Gatwick Airport Northern Runway Project

Examination Ref: TR020005

Joint Local Authorities Response to the Applicants Deadline 4 Submissions and response to the Applicants Written summary of oral submissions ISH6. ISH7 and CAH1

Deadline 5: 6 June 2024

Figure 1: Proportion of Gatwick Aircraft Movements by New Generation Aircraft

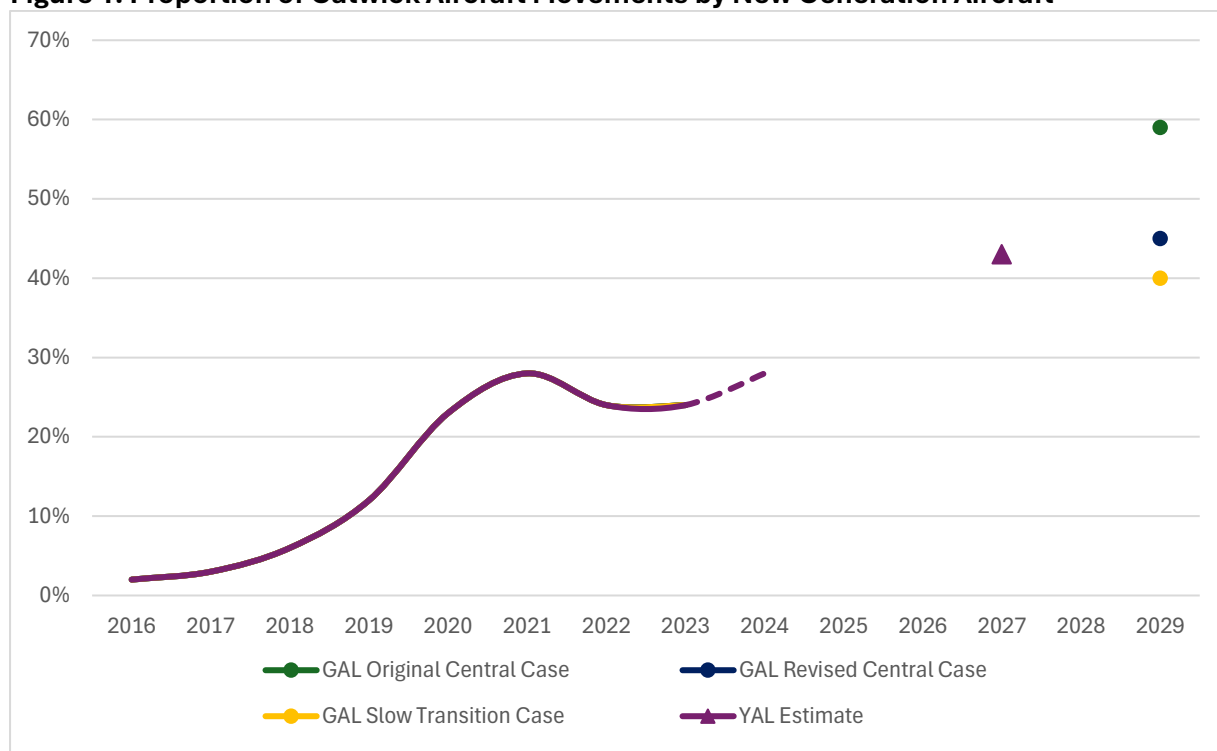
Figure 1 below shows how this fleet transition would sit with the Applicant's original and updated fleet transition assumptions, using the historic data set out in Diagram 2.3 of **REP4-004**.

7. There are a number of reasons why a transition to 43% of movements being by new generation aircraft in 2027 could be considered conservative:

9. The revised Central Case set out in **REP4-004**, suggests that the slow down in deliveries will continue to 2029 and accelerate thereafter, which does not appear to accord with airlines’ expectations. The fleet transition indicated for 2029 in the revised case looks virtually identical to that we estimate as attainable in 2027 and, hence, would be considered a conservative slow transition case. Our updated analysis also confirms our view that the current Slow Transition Case is overly conservative, with a predicted fleet transition in 2029 lower than we have estimated for 2027 based on recent fleet orders and general market intelligence. Whilst this does mean that the assessment of noise, and other topics that relate to the fleet assumptions used, will be a worst case, this does
